SIB 11 10 21

RECALL 21V-907: EXHAUST GAS RECIRCULATION (EGR) COOLER – N57T LOW TEMPERATURE

This Service Information Bulletin (Revision 5) replaces SI B11 10 21 **dated January 2024**.

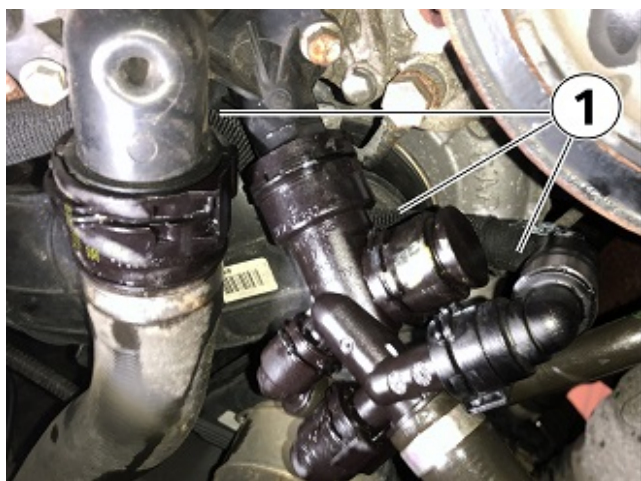
Hint: Record or take a photo of the following numbers on the new EGR cooler before installation (1, 2 and 3). These numbers will be required later to register the new cooler in ISTA.

1. Production date [YY-MM-DD]
2. Revision index
3. Serial number
